ADDENDUM NUMBER 3

Project: C. Wayne Stevens, Jr. Public Safety Facility
Highlands Business Park – Owens Drive
Glade Spring, VA 24340

Date: June 12, 2026

DATE:	01-30-2026
NO.	REVISION DATE
1	05-12-2025
2	
3	
SHEET:	A604
DRAWN BY:	DMW
CHECKED BY:	MRL
PROJECT NO:	TLG-2515
THE LANE GROUP INC.

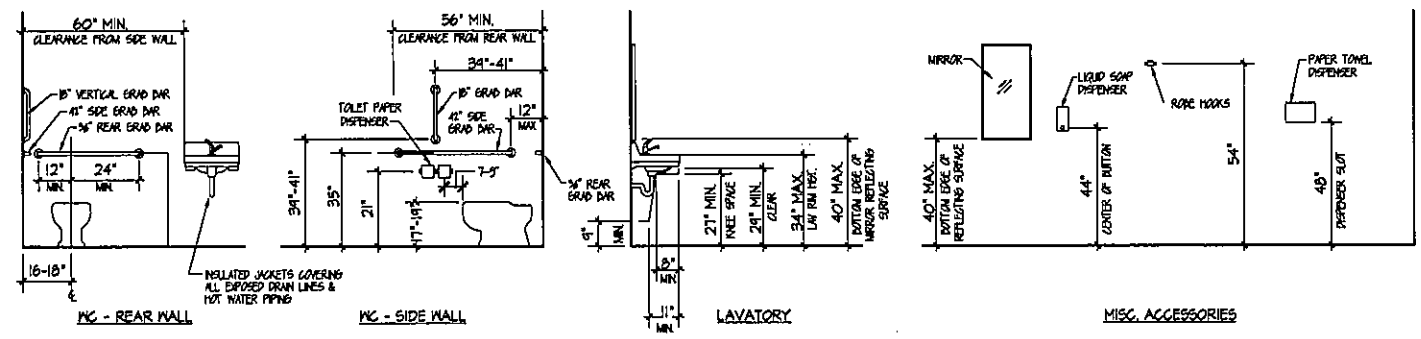
5. **Refer to Drawing A604, “Finish Schedule / Toilet Accessory Schedule”:** Drawing A702 was released as a part of Bid Addendum #2. Drawing A604 is revised, by this Addendum, to reflect the floor finishes indicated on Drawing A702.

SHEET A701

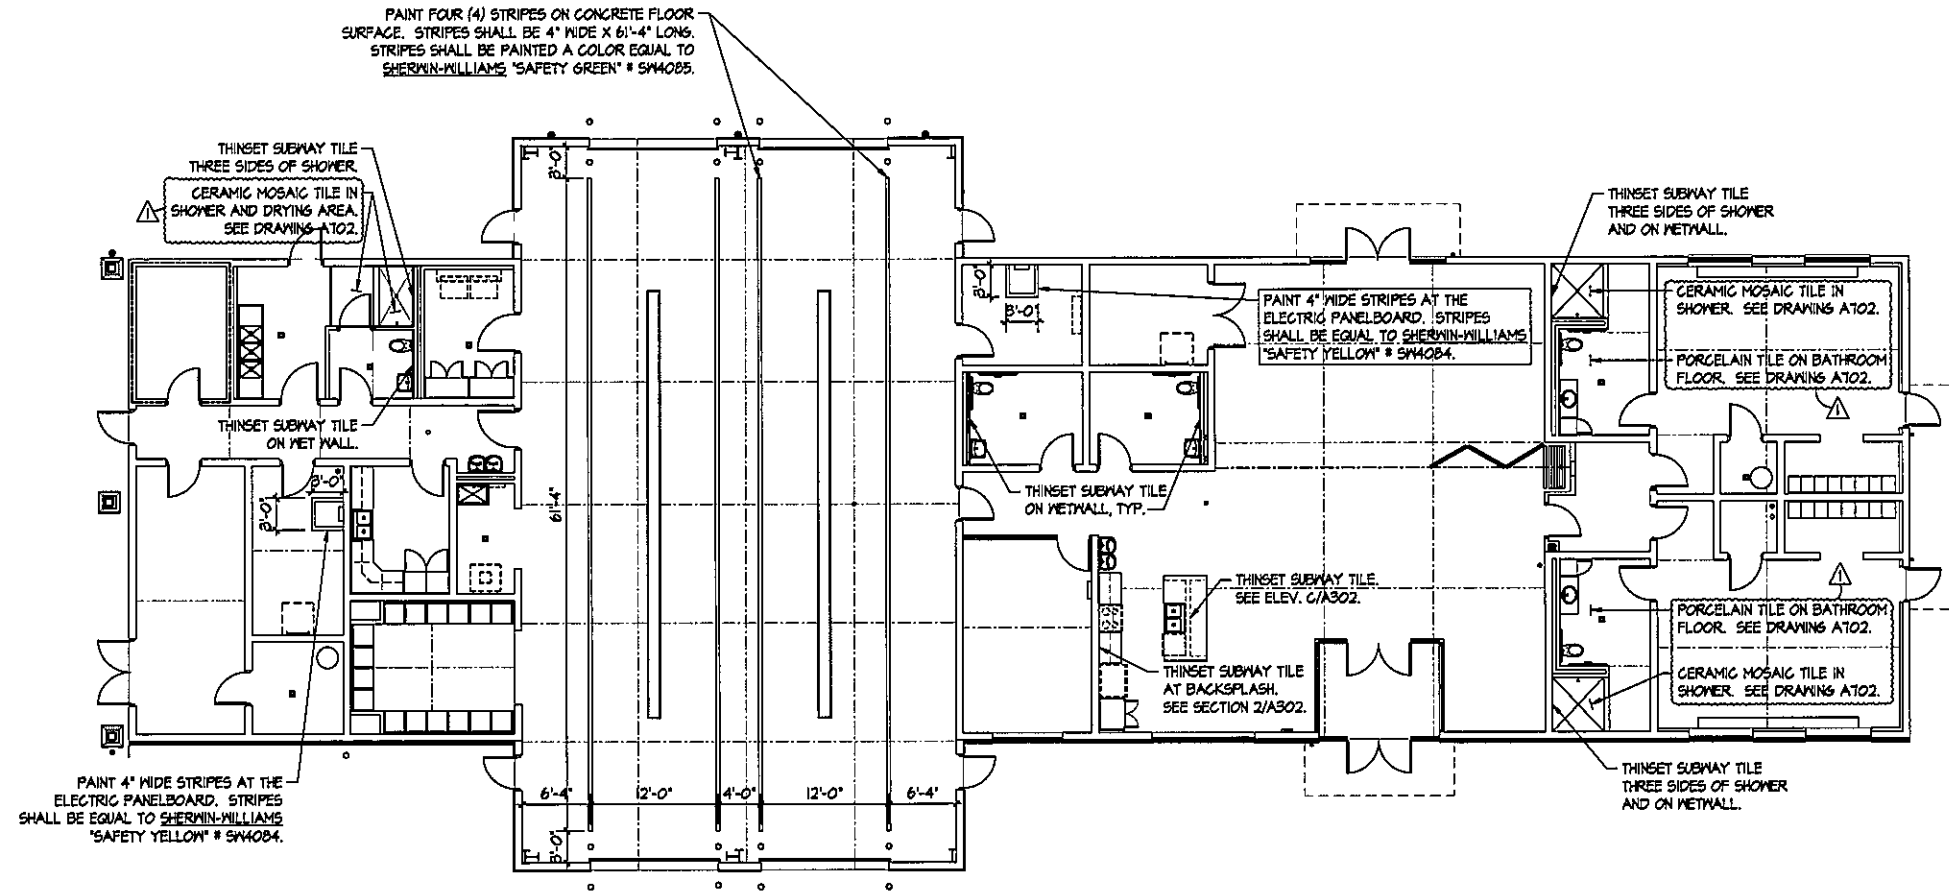
6. **Refer to Drawing A701, “Finishes Floor Plan”:** Drawing A702 was released as a part of Bid Addendum #2. Drawing A701 is revised, by this Addendum, to reflect the floor finishes indicated on Drawing A702.
